Correction: A smart multi-pipette for hand-held operation of microfluidic devices

Correction for 'A smart multi-pipette for hand-held operation of microfluidic devices' by Byeongyeon Kim et al., Analyst, 2016, **141**, 5753–5758.

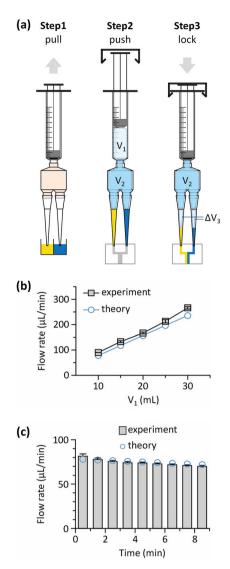
To reflect this change, amendments are required to Fig. 1 and the text.

- · Fig. 1b and c are affected by the correction needed to the theoretical estimation for the generated pressure by the smart pipette, and the overall corrected version of Fig. 1 is as follows:
 - The first sentence on p. 5755 should be amended as follows:
- 'If $V_2 \gg (\Delta V_3)_t$ and $V_1 \gg (\Delta V_3)_t$, the pressure change becomes negligible and thus the smart multi-pipette maintains a constant pressure during device operation.'
 - The fourth sentence of the third paragraph on p. 5755 should be amended as follows:
 - 'We note that the experimental value is higher than the theoretical expectation of 7.8%.'
 - The changes do not affect any of the conclusions of the article.
 - The Royal Society of Chemistry apologises for these errors and any consequent inconvenience to authors and readers.

$$P_{n+1} = \frac{V_1 - (\Delta V_3)_t}{V_2 + (\Delta V_3)_t} P_{\text{atm}}$$
(3)
